**Developing a Large Woody Debris Budget for the Lower San Antonio River
Draft-final report to the Texas Water Development Board**

Contract number 1104831140

REQUIRED CHANGES

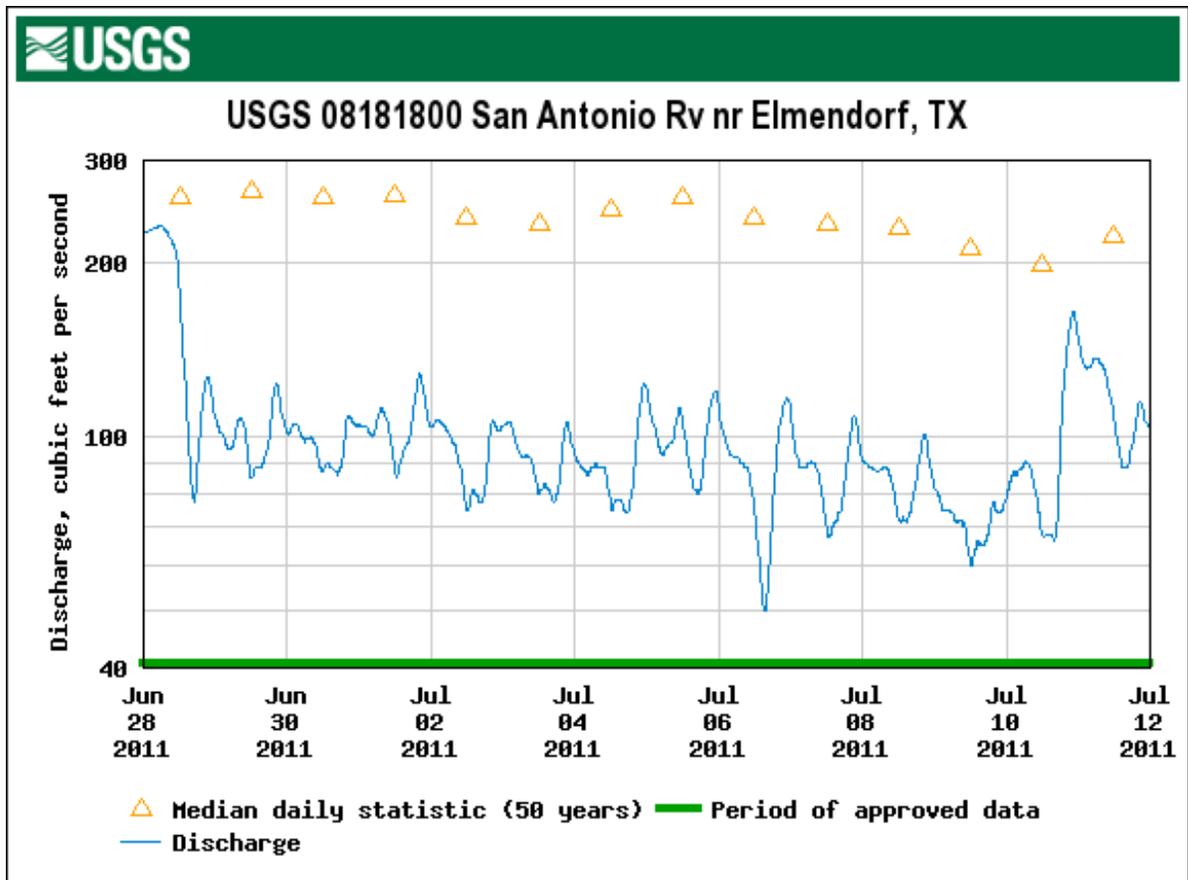
3. The discharges reported in Table 5 on page 36 appear to be in error. For example, for the Calaveras site, average river discharge during the sampling period is reported as 30.18 cubic meters per second. This would be equivalent to more than 1,000 cubic feet per second, a very significant flow for this river at this location. During the sampling period, the USGS gage near this site recorded flows closer to 100 cubic feet per second (see figure below). Please recheck the values in Table 5 and revise as necessary.
